SERVICE BULLETIN #1074

SUBJECT CLUTCH SHOE DAMAGE

MODEL 1-80, 55 Series DATE 9-22-59

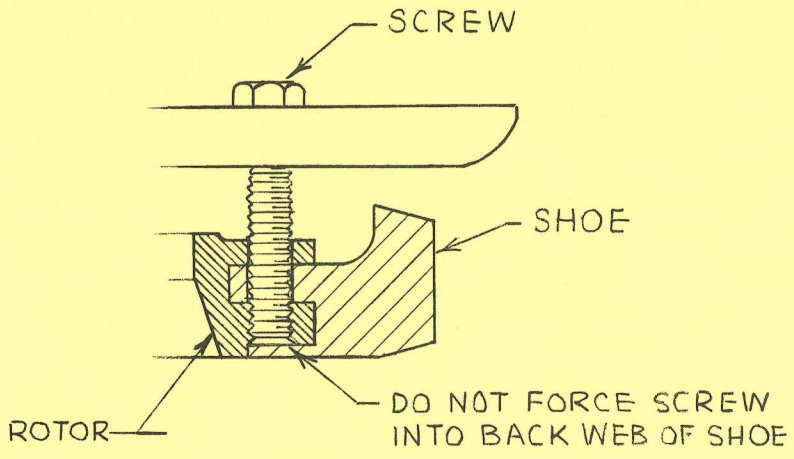
When using the clutch puller tool to remove the clutch assemblies which contain the new cast iron shoes, do not jam the clutch puller attaching screws against the cast iron shoes. If the screws are jammed against the cast iron shoes, the shoes may be damaged or broken.

To avoid jamming the clutch puller attaching screws, gently turn-in the screws until you feel them bottom against the clutch shoes. Then, back them off one full turn and remove the clutch assembly in the usual manner.
